**SITE WIDE COMPREHENSIVE ENVIRONMENTAL  
RESPONSE, COMPENSATION, AND LIABILITY  
ACT (CERCLA) QUALITY ASSURANCE PROJECT  
PLAN (SCQ)**

**DOE-0483-93  
DOE-FN/EPA**

SUBJECT: Review of Department of Energy's Response to USEPA's Conditional Approval of the Quality Assurance Project Plan (QAPjP) for the CERCLA Remedial Investigation/Feasibility at the Feed Material Production Center (Fernald, Ohio)

SAMPLE CUSTODY FLOWCHART

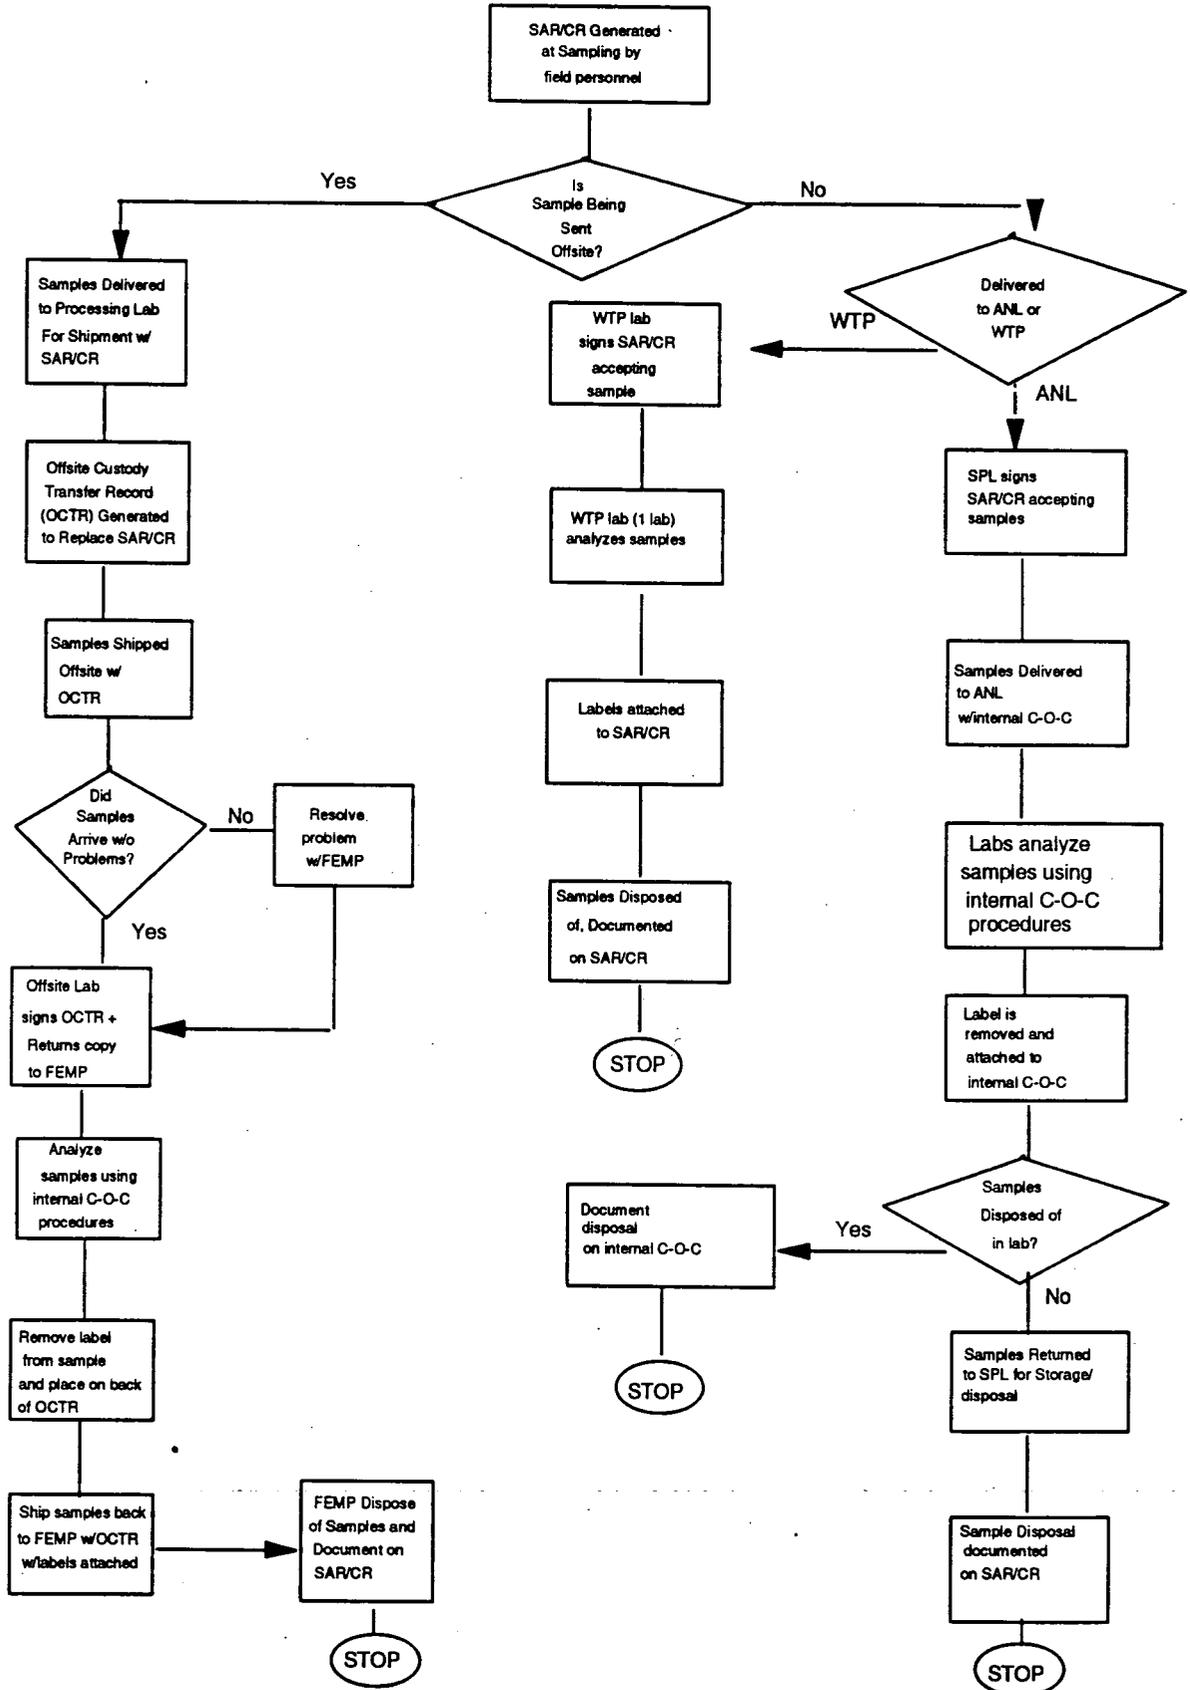
The Sitewide Analysis Request/Custody Record (SAR/CR) needs to provide an adequate number of signature/date/time spaces for a complete custody record including transfers in the field as well as for continuation of sample receipt/transfers at the laboratory. The field custody procedure should state that a separate SAR/CR will need to be completed for each laboratory performing analyses (i.e. chemical versus radiological, organic versus inorganic).

WEMCO agreed to develop a flow chart to better explain the chain of custody process (see attached). EPA agreed with this response.
